State of New Mexico
 Energy, Minerals and Natural Resources

WELL API NO. 30-025-01269
5. Indicate Type of Lease STATE <input checked="" type="checkbox"/> FEE <input type="checkbox"/>
6. State Oil & Gas Lease No. 303863
7. Lease Name or Unit Agreement Name New Mex A
8. Well Number 2
9. OGRID Number 253010
10. Pool name or Wildcat 96116 SWD Permo Upper Penn

SUNDRY NOTICES AND REPORTS ON WELLS
 (DO NOT USE THIS FORM FOR PROPOSALS TO DRILL OR TO DEEPEN OR PLUG BACK TO A DIFFERENT RESERVOIR. USE "APPLICATION FOR PERMIT" (FORM C-101) FOR SUCH PROPOSALS.)

PERFORM REMEDIAL WORK ☐ PLUG AND ABANDON ☒
 TEMPORARILY ABANDON ☐ CHANGE PLANS ☐
 PULL OR ALTER CASING ☐ MULTIPLE COMPL ☐

New Mexico A # 2
Lea, NM
3-Jul-17

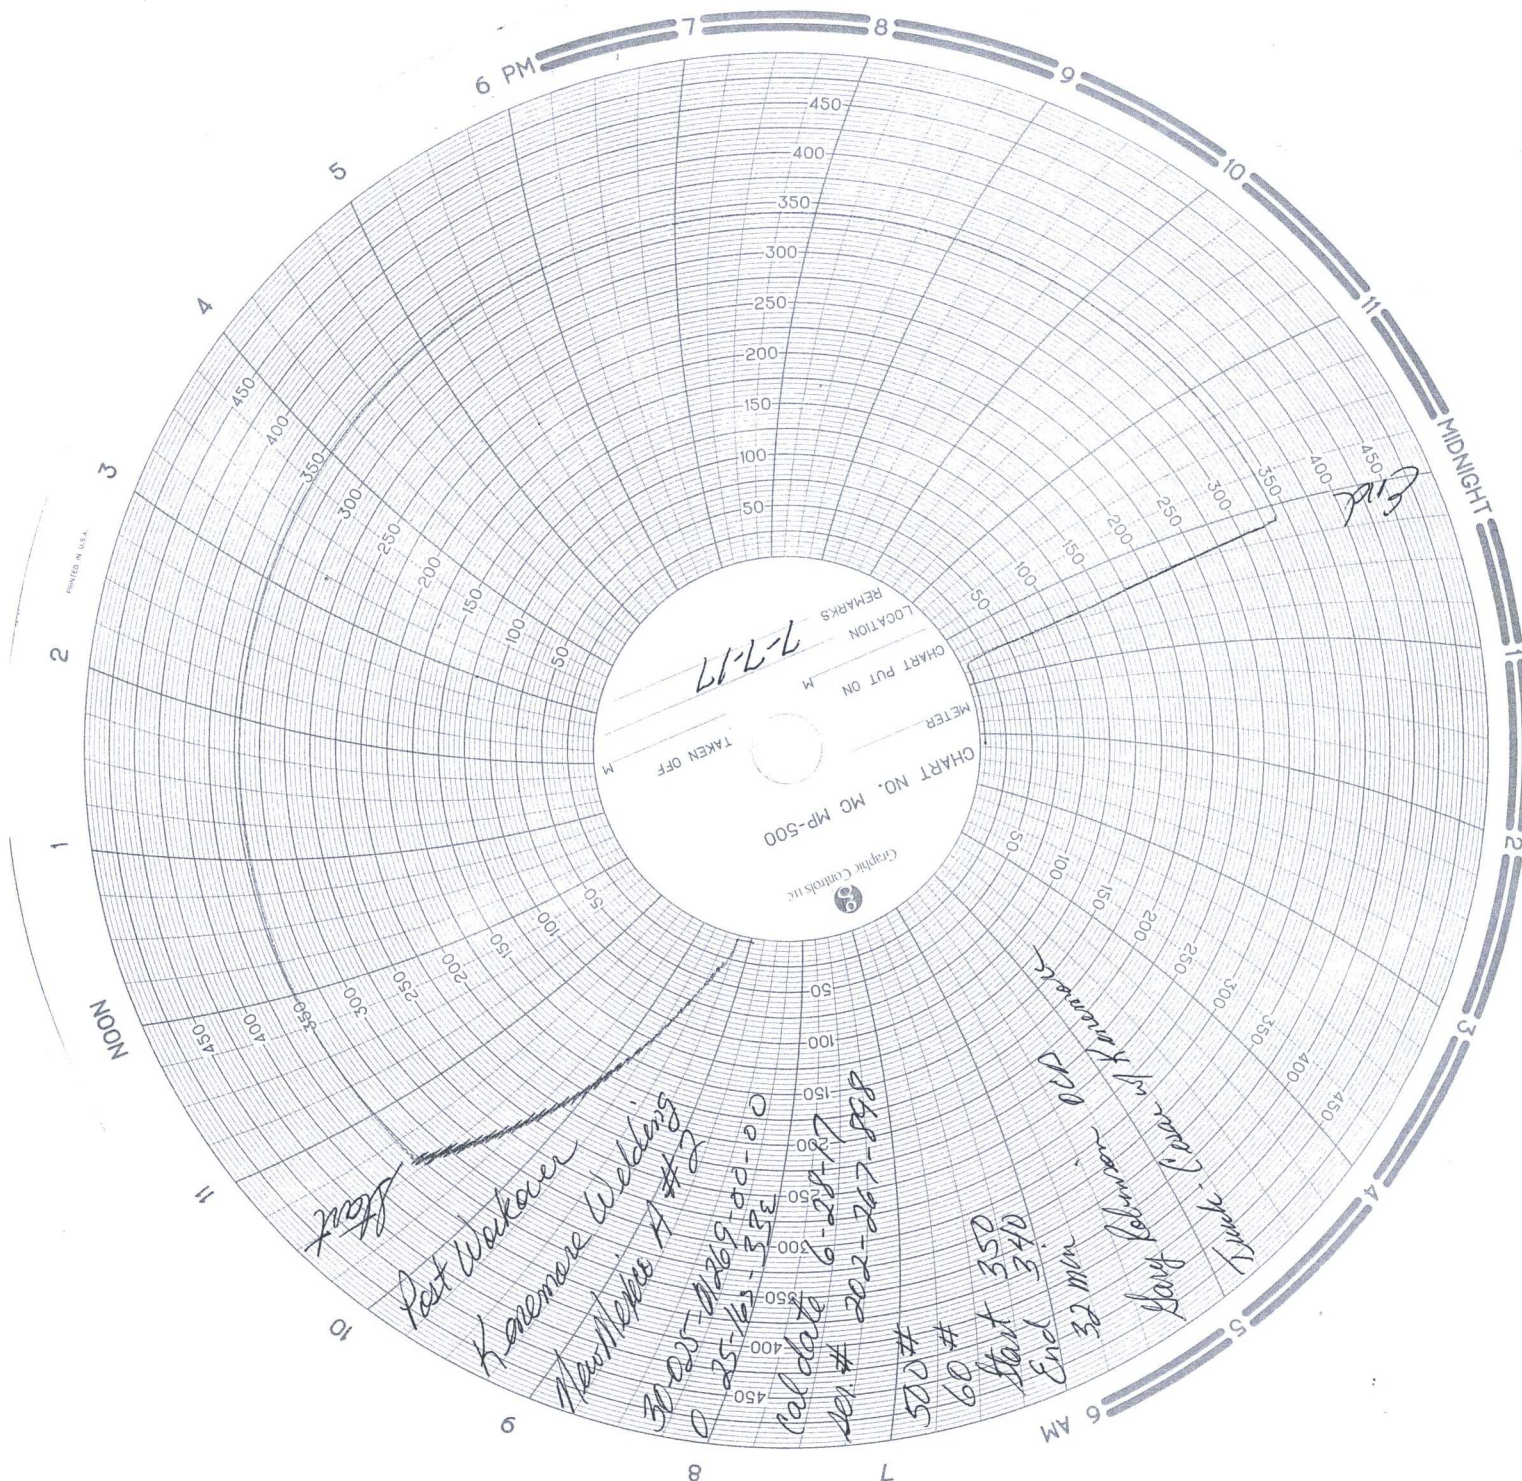
DENIED

Perforations shown ON
 W. Diagram AS new are outside
 Approve SWD-1088 order.
